1963 Corvette: Service Bulletin: Interim Production Changes

Subject: Interim Production Changes
Model and Year: 1963 Corvette
Source: Chevrolet Technical Service Bulletin
Bulletin No: DR #569
Section: XV
Date: December 31, 1962

PARKING BRAKE LEVER ASSEMBLY REPLACEMENT

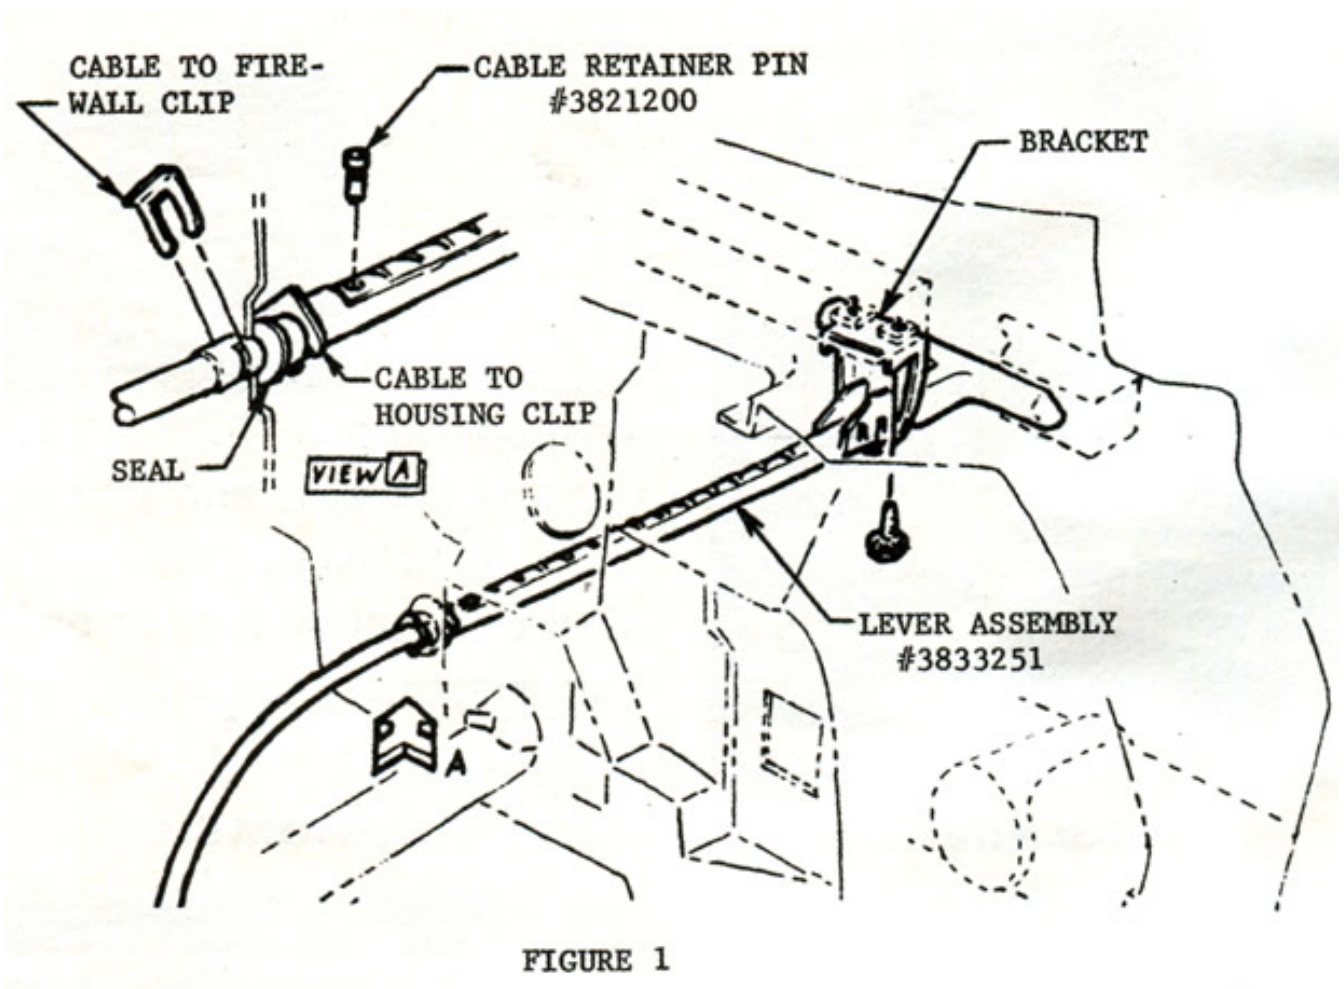
1. Effective with Serial No. S101893, a redesigned parking brake lever assembly entered Production. Early vehicles incorporate a lever assembly which may be difficult to release and in extreme cases, may actually jam making release impossible.
2. Vehicles with Serial No. S101847 through S102667, were built with a second design rear axle driveshaft flange that may not seat properly in the rear wheel drive spindle flange. An interference condition at this location could possibly lead to early failure of the rear wheel spindle flange attaching bolt bosses.

Lever Assembly should be replaced on all vehicles built prior to Serial No. S101893. Referring to Figure 1, proceed as follows:

1. Scrape sealer away from cable to firewall clip and remove clip.
2. Disconnect parking brake cable clip from steering gear retainer bolt.
3. Disconnect oil pressure line at gauge and pull line out of parking brake lever assembly bracket.
4. Remove two (2) bolts holding bracket to dash brace.
5. Pull complete lever and cable assembly to the rear, far enough to remove parking brake signal switch.
6. With handle all the way in, cable retainer pin will line up with hole in bottom of housing allowing pin to be driven out from bottom with a punch.
7. Remove cable to housing clip and separate cable from housing.
8. Install original seal on new lever assembly No. 3833251.
9. Reassemble by reversing the above steps using new cable retainer pin No. 3821200. NOTE: Chamfered side of pin must face forward to

actuate the parking brake signal switch properly.

10. Apply body sealer around cable at firewall to prevent water leaks.

FIGURE 2

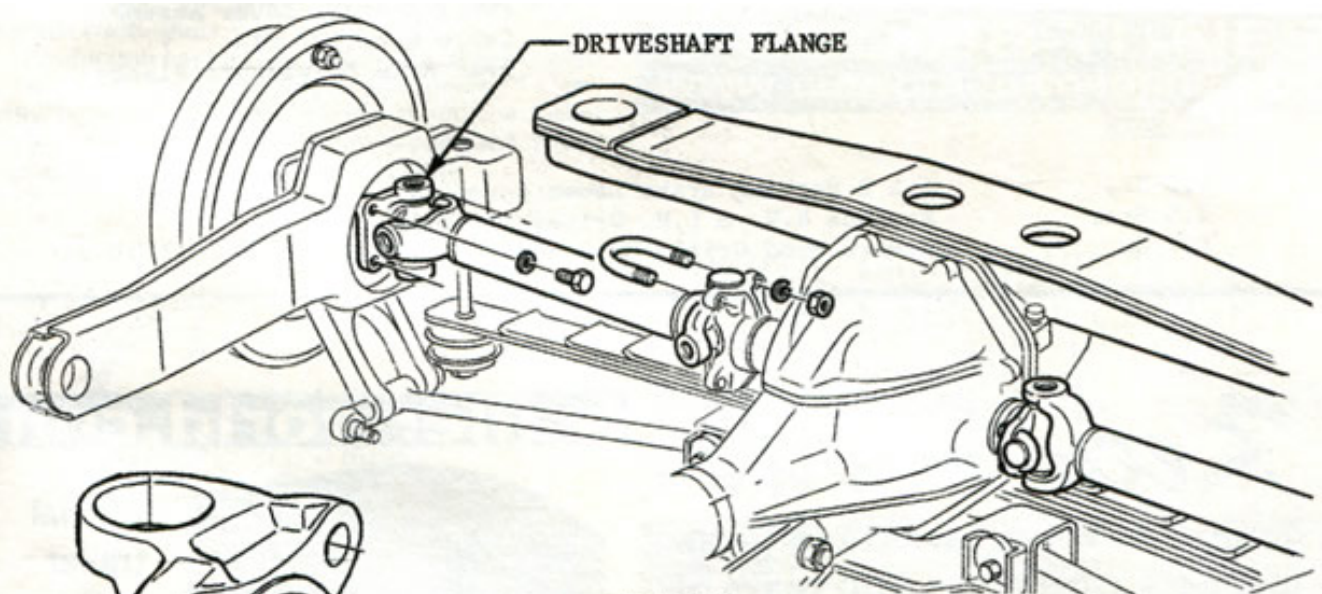
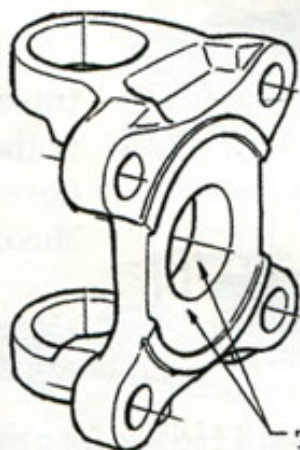
New machined Driveshaft Flanges No. 3832048, should be installed on all vehicles with Serial No. S101847 through S102667 (Ref. Figs. 2 and 3).

THESE SURFACES
MACHINED FOR
CLEARANCE

FIGURE 3 - DRIVESHAFT FLANGE

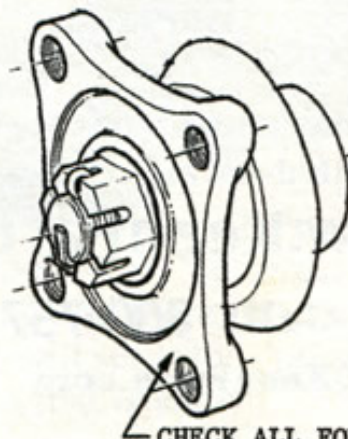
Replacement of the driveshaft flange is covered in the 1963 Corvette Shop Manual, Page 4-16. The rear wheel spindle flange attaching bolt bosses should be visually inspected while the axle driveshafts are out of the vehicle. Replace with new Spindle Flange Assembly No. 3830253 if any cracks are evident in the area indicated in Figure 4.

CHECK ALL FOUR
BOSSES FOR CRACKS
IN THIS AREA
